Peach Bottom Atomic Power Station, Units 2 and 3
Facility Operating License Nos. DPR-44 and DPR-56
NRC Docket Nos. 50-277 and 50-278

Subject: Response to Request for Additional Information Related to Severe Accident
Mitigation Alternatives

Reference: Letter from L. L. Wheeler (USNRC) to M. P. Gallagher (Exelon), dated
December 20, 2001

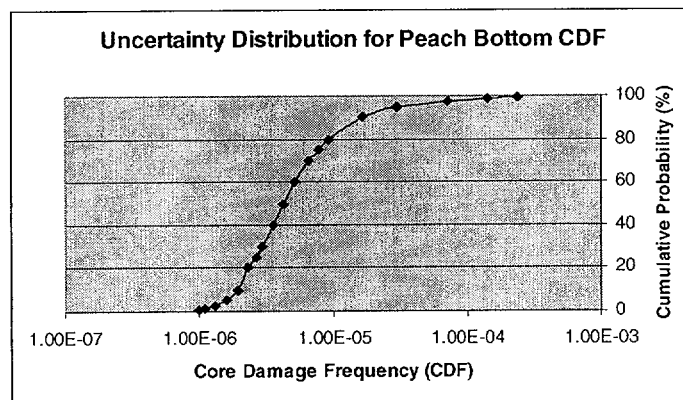
- b. ***An assessment of the impact of including the risk from external events in the SAMA identification and screening process. It is recognized that the methods used for the Peach Bottom IPEEE do not provide numerical estimates of the CDF contributions from seismic and fire initiators; however, quantitative estimates for CDF and risk for external events at Peach Bottom are available in NUREG/CR-4551, and can be used to account for the impact of external events in the SAMA analysis. This impact can be substantial since the risk associated with external events in NUREG/CR-4551 (e.g., 57 person-rem per reactor year for fires) is much greater than the total risk estimate used in the SAMA analysis (14.7 person-rem per reactor year),***

A Monte-Carlo propagation of data uncertainty was performed for the Peach Bottom Unit 2 PSA model using the WinNUPRATM software. The results of that analysis are summarized below.

Confidence	CDF
5 th	1.57E-06
25 th	2.63E-06
50 th	4.24E-06
75 th	7.76E-06
95 th	3.00E-05

The 95th percentile associated with this distribution is 3.00E-05/yr. The SAMA baseline CDF of 4.5E-06/yr corresponds to approximately the 55th percentile of this CDF distribution. There are many factors to consider, however, when looking at the benefits of the SAMA candidates. Plant specific implementation of SAMA candidates may be complicated by space limitations, outage costs, regulatory requirements, and other considerations. These factors tend to result in underestimation of the costs. Additionally, the specific PSA analyses that were performed in addressing specific SAMA candidates were done optimistically. That is, the potential cost-benefit was derived from a case that maximized the CDF reduction that would result from implementation of the SAMA. Both of these factors would, in effect, offset the uncertainties associated with the CDF estimates.
